2015 Configuration with RDI Leave Addition Comparison with Rennie's Suggestions

Introduction to VIA Report

FL A87597 will lay on a landform previously impacted by large, angular cutovers. An initial plan of rehabilitation of the cutovers was prepared in 2013 and 2014 by BCTS. RDI prepared a VIA based on that plan. The plan had the objective to reduce the amount of forest between the cutovers at an early enough stage so that old and new cutovers would merge to reduce the horizontal line effect, and to allow re-growth together into a single-aged large pattern of openings.

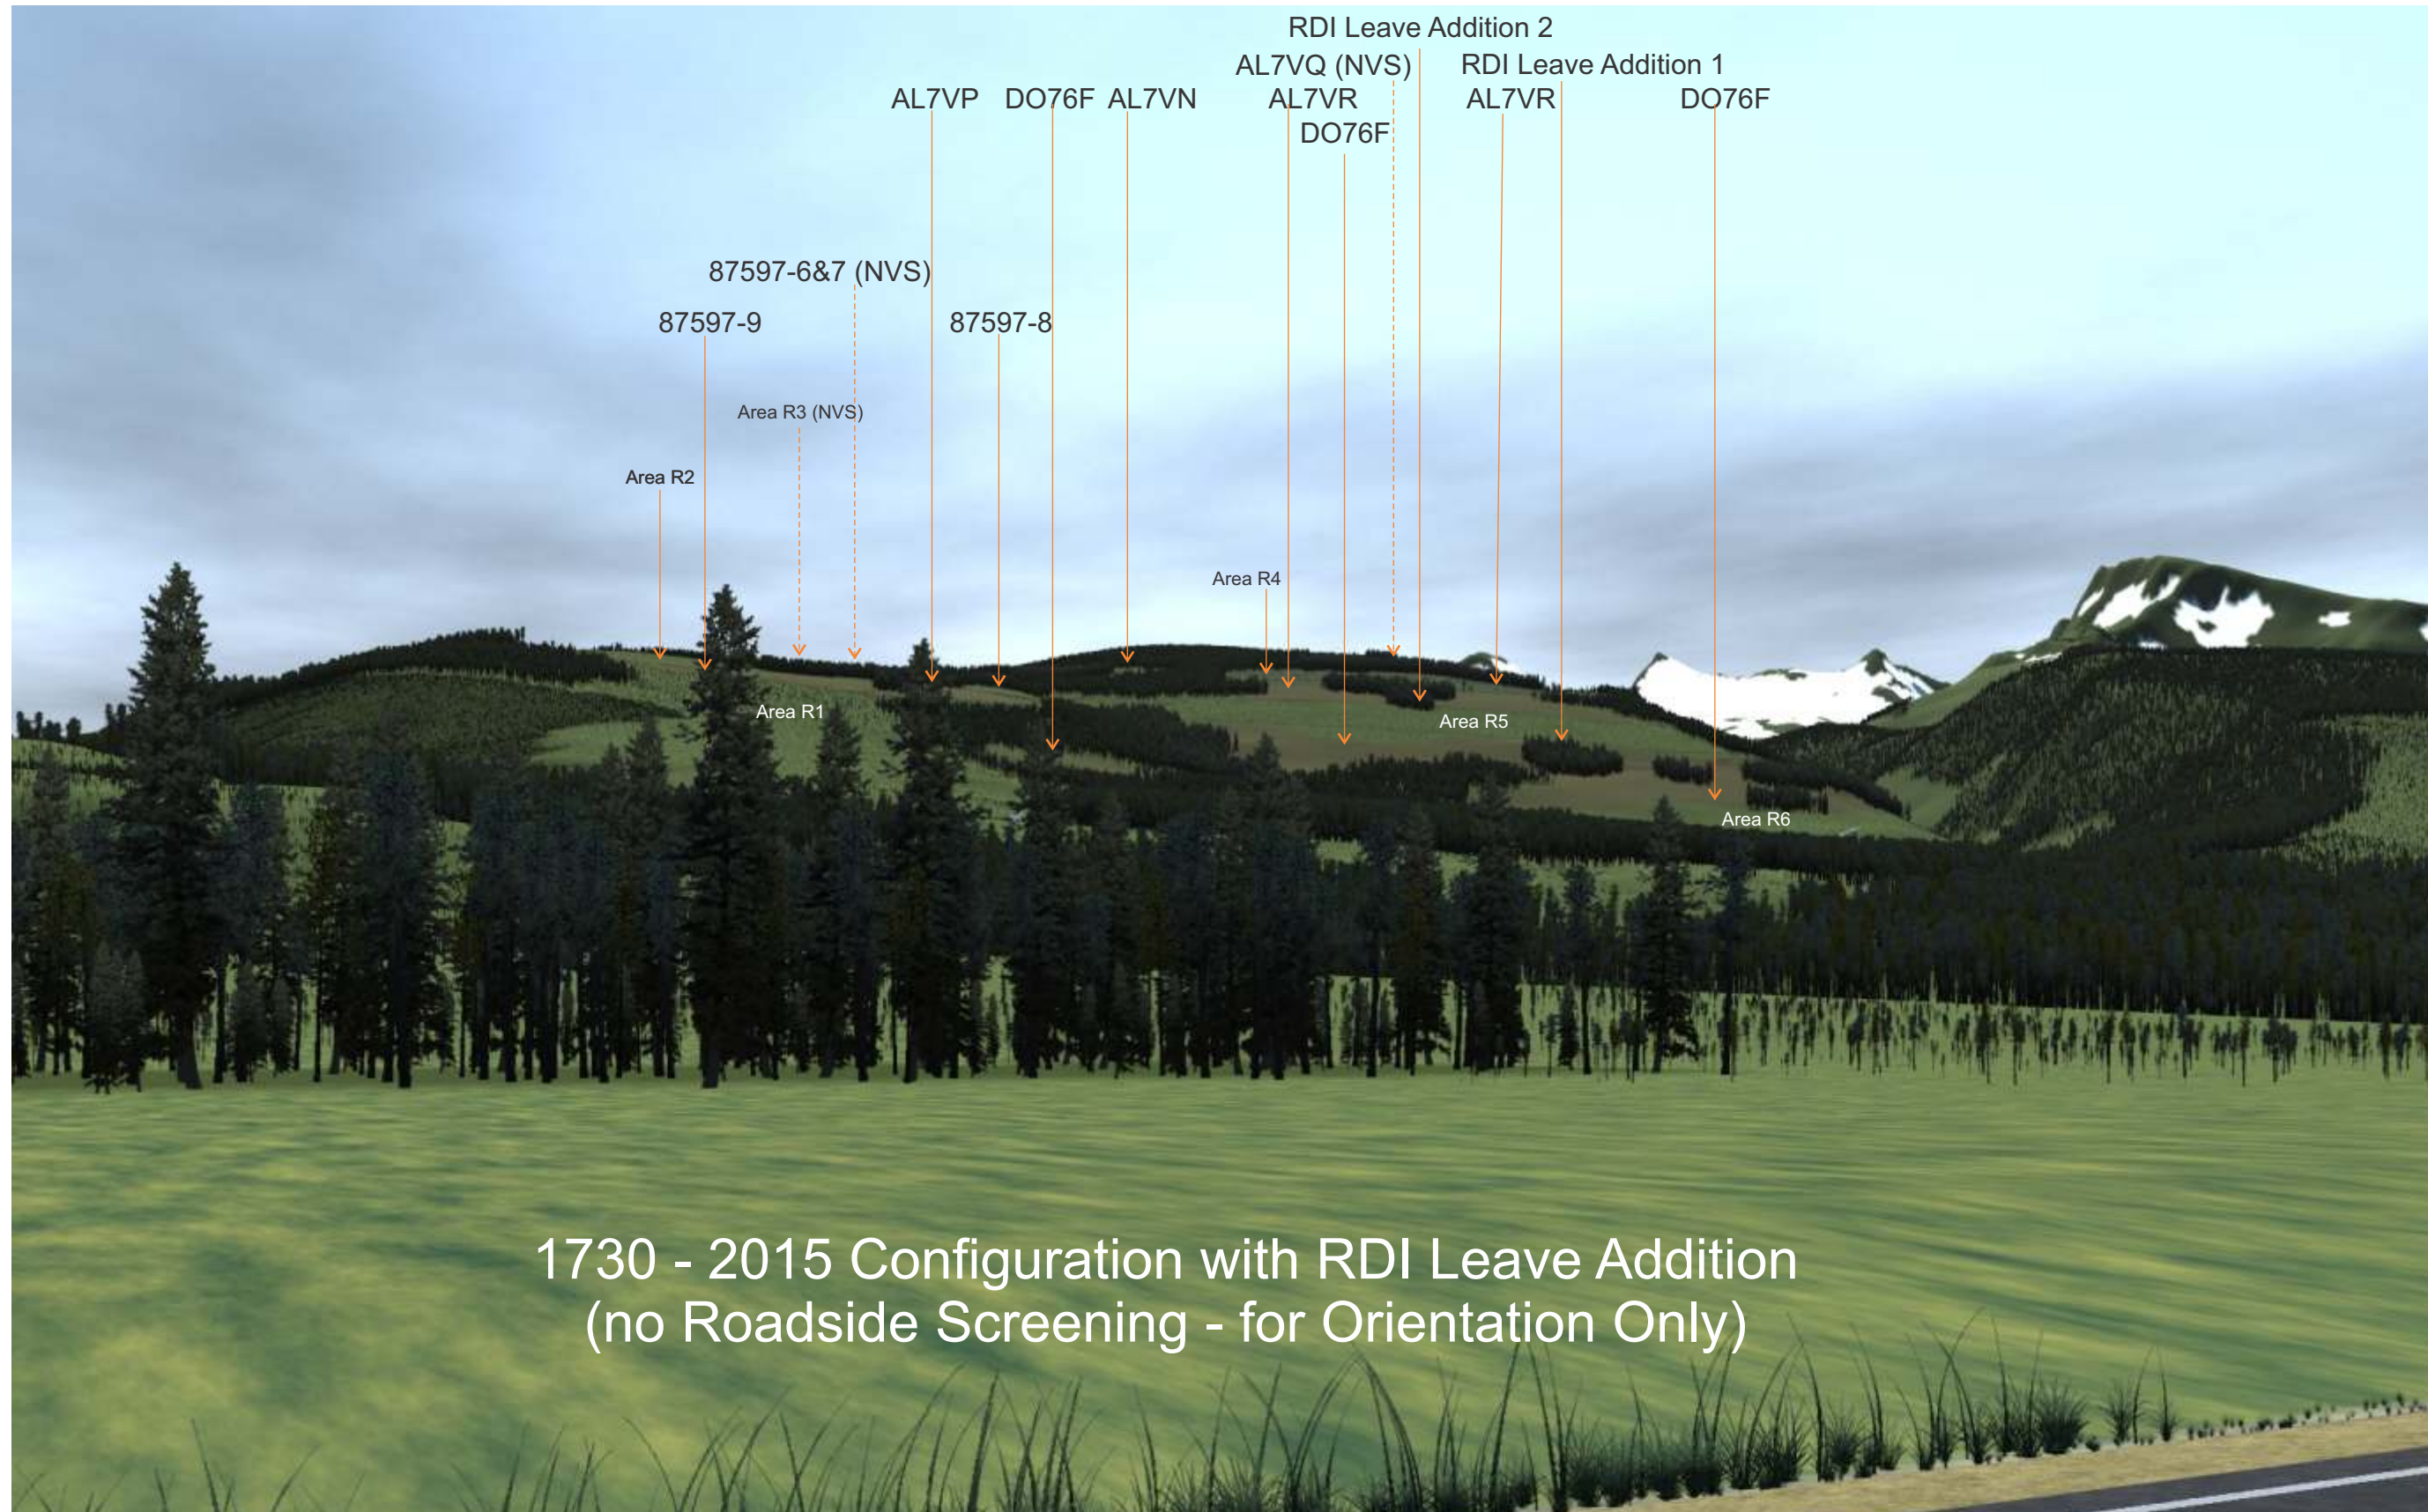
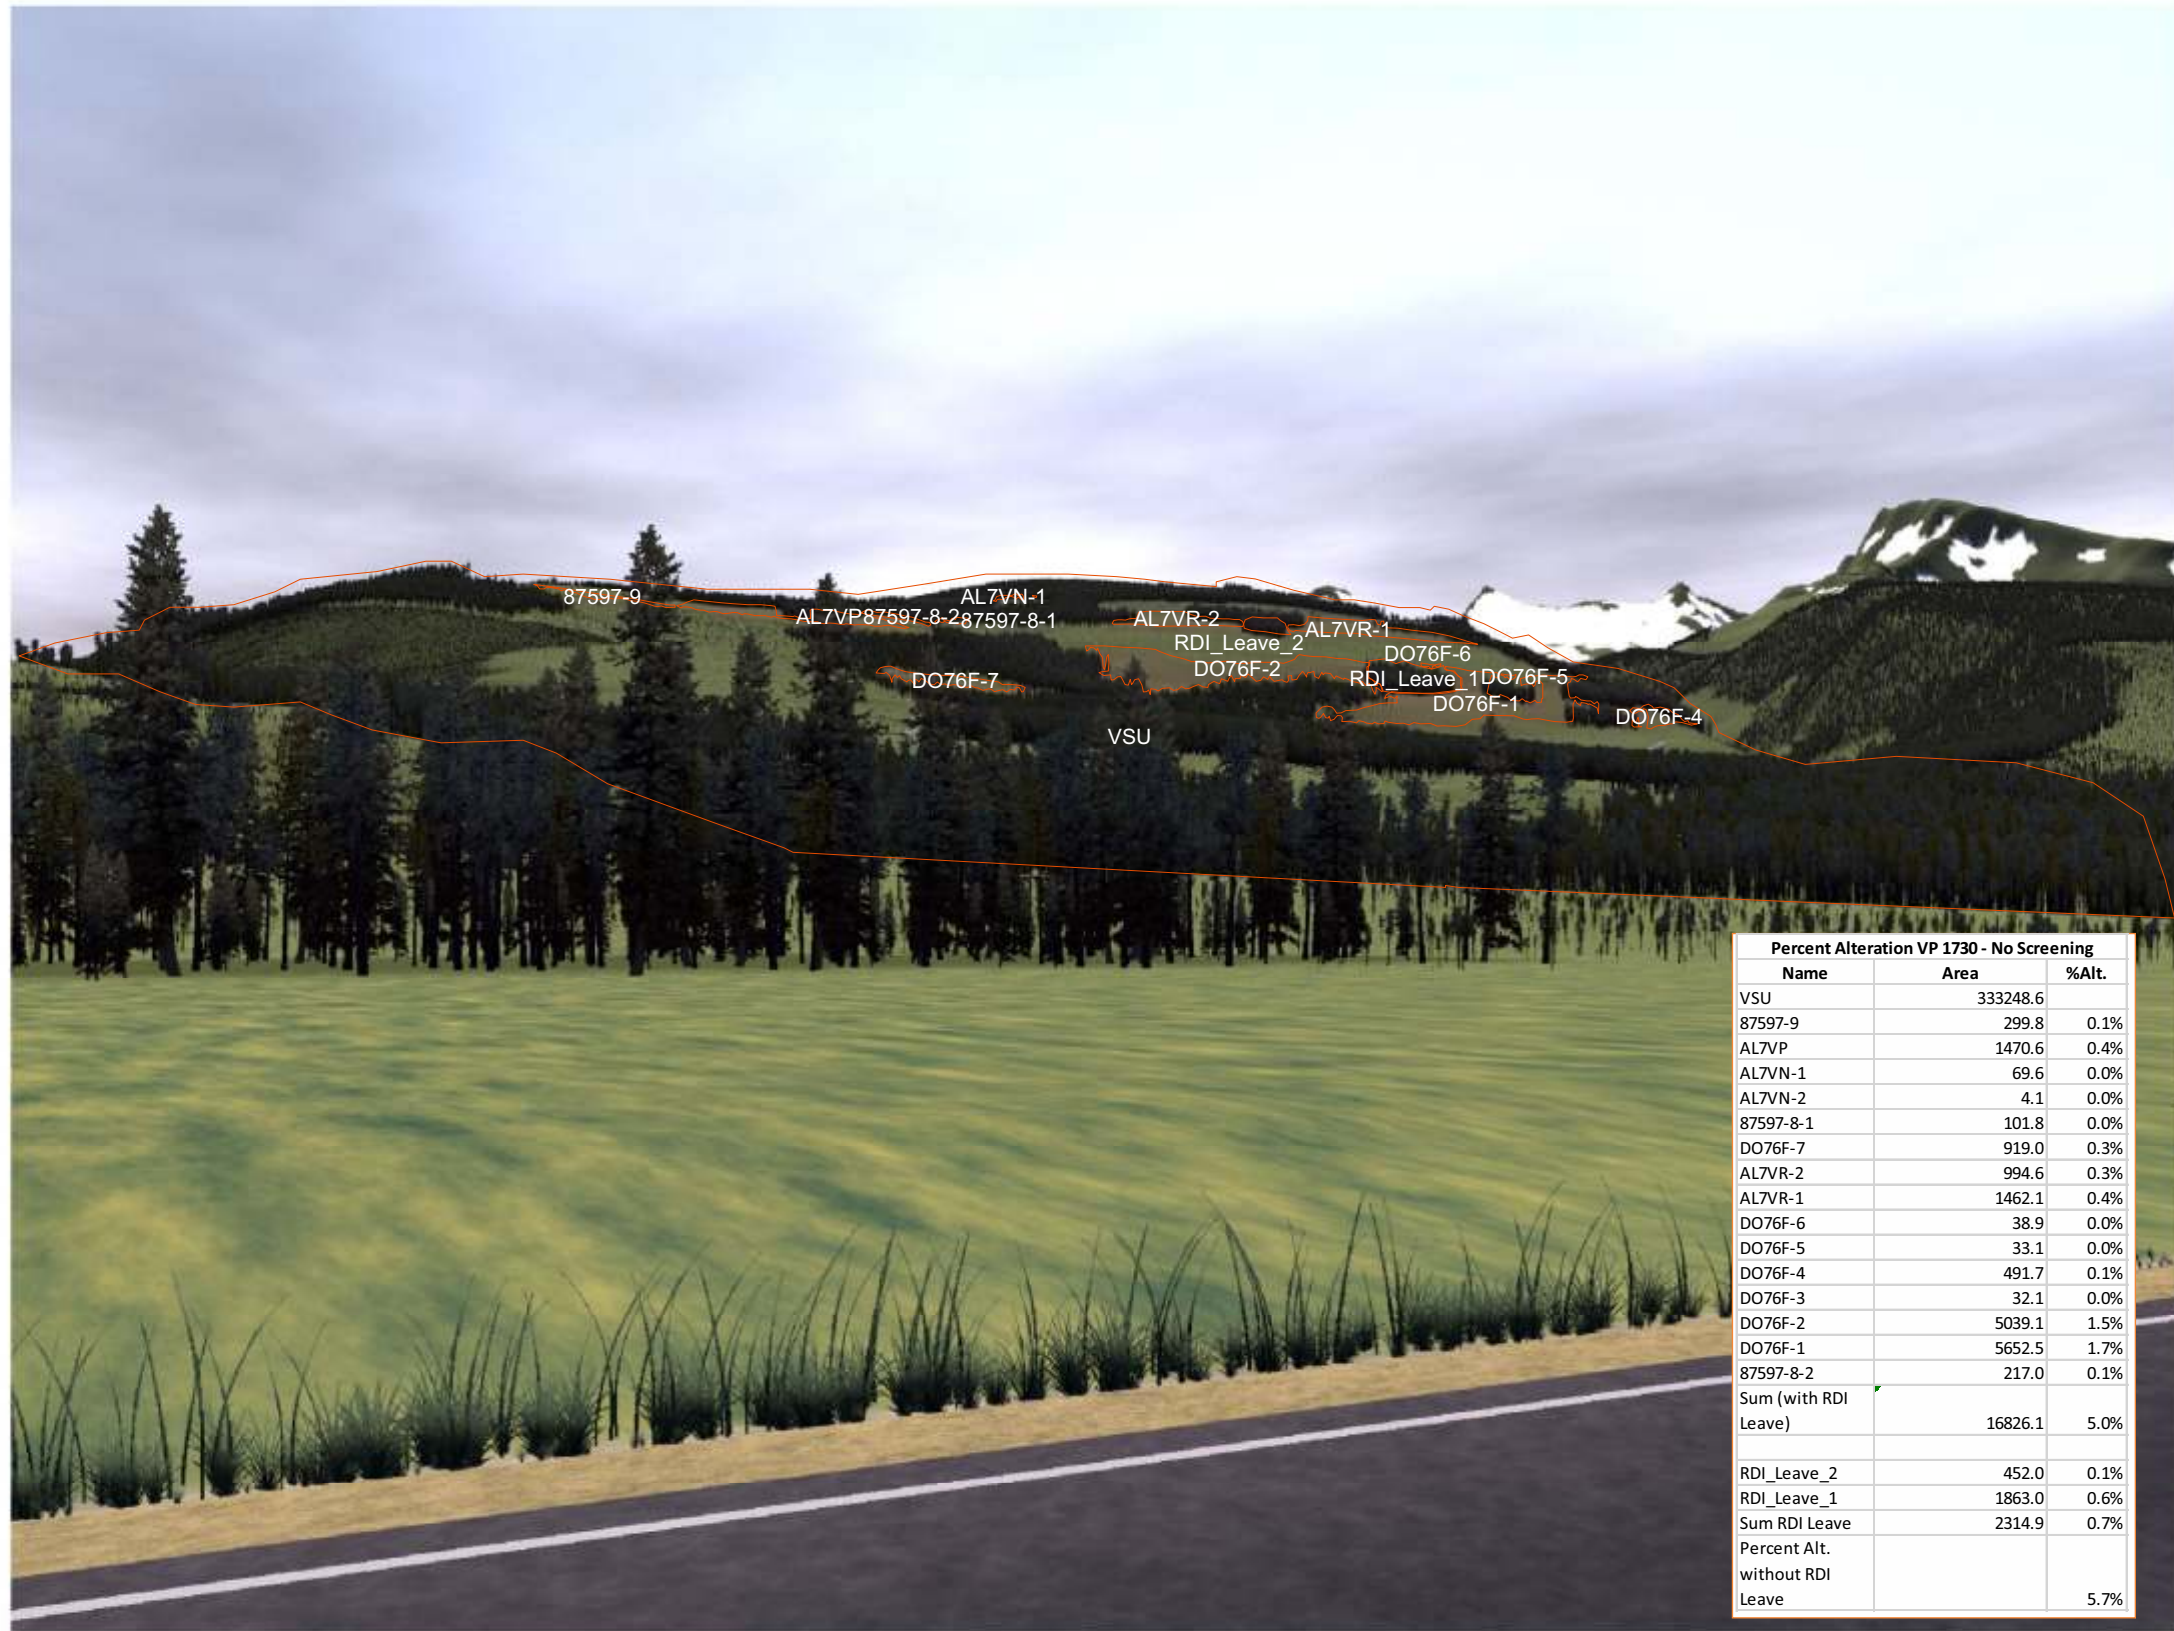
Comparison of Final Design with Rennie Suggestions		
Rennie's Numbers (Old Cutovers)	Rennie's Suggested cut and leave (numbered by RDI)	Comparative Results
1	8 - cut	No comparable in BCTS - no operations
2	9 - cut	same as BCTS 87597-9 new block; leave patch in AL7VP between Areas 2 and 5
3	1 - cut	same as BCTS 87597-7 new block
	2 - cut	same as BCTS 87597-6 new block
	3 - cut	same as BCTS AL7VN plus leave
4	7 - cut	no comparable in BCTS - covers leave area (reverse of suggestion). BCTS leave area screens upper road in AL7VQ
4-5 gap	5 & 6 leave areas	leave areas same as BCTS leave areas in BCTS AL7VR. RDI recommended tiny additional patch at base of central leave patch to tie into Area 5
5	4 - cut	same as BCTS 87597-8 new block
5-6 gap	none defined	Rennie's suggested lower boundary of Areas 5 could be more irregular. BCTS responded with 4 leave patches in DO76F. RDI recommended 1 more (2ha) for more continuity through the block

6	none defined	BCTS and RDI leave areas provide greater tie-in between existing cutovers

Old Openings (Rennie Numbers)	Rennie Suggestion Cut / Leave	Achievement of Rennie Suggestions	Comments
Area 6	make link through block DO76F	Achieved	DO76F above works to weaken Area 6. Rennie recommended linkage through block; BCTS Leave patches and RDI additional leave area provides increased linkage through block.
Area 5	4	Achieved	BCTS 87597-8 same as Rennie 4 - weakens upper line of Area 5. DO76F below and AL7VR above work to break up straight lines of Area 5.
	5	Achieved	Rennie recommended linkage through block; BCTS Leave patches and RDI additional leave area provides significant, well-designed linkage through block. RDI patch added to improve flow with lines of force.
	6	Achieved	Minor angularity from viewpoints. R6 covered by BCTS leave area.
Area 4	7	not Recommended by RDI	Rennie 7 would eliminate much a BCTS leave area below AL7VQ. Larger Rennie 7 opening would introduce 0.7% additional alteration. Not recommended by RDI except perhaps a small opening to reduce corner of Area 4. Leave areas in AL7VR including small additional RDI patch provide some linkage with good design. BCTS leave area partly overlaps Rennie 7.

12	achieved	BCTS Leave covers similar area as Rennie opening 7. Rennie 12 is actually a BCTS leave area. BCTS AL7VN, 87597-6, and 87597-7 cover most of Rennie openings around Area 4.
Area 3	3	not recommended by RDI	Rennie 3 would enlarge opening around Area R3 and eliminate a BCTS leave area (adding 0.7% to total percent alteration). Areas R1 and R2 were already identified as leave areas by BCTS.
	2	achieved	Replicates Rennie's suggested block 2 to weaken Area 3.
	1	achieved	Replicates Rennie's suggested block 1 to weaken Area 3 (but not seen).
Area 2	9	achieved	BCTS 87597-9 same as Rennie 9 small sliver associated with AL7VP.
			Small leave area breaks AL7VP; provides flow-through connected to stronger force line above. Perhaps make larger to be fully effective.
Area 1	8	not recommended by RDI	No BCTS block to address Rennie 8; Advanced Regen. Rennie 8 would weaken strong forest band above, and would add 2.5% to total percent alteration. Hold on to most of the limited forest above Area 1 - good shape. Total alteration already large enough. For example, from Viewpoint 1730.3, it is 10% without the Rennie additions 3, 7, and 8. These additions would add another 3.9% to bring it to a total of 13.8%. Overall percent alteration will have to be reduced to meet PR, but not necessarily if rehab is the approved management decision. No greater incursions should be contemplated until the area is restored visually.
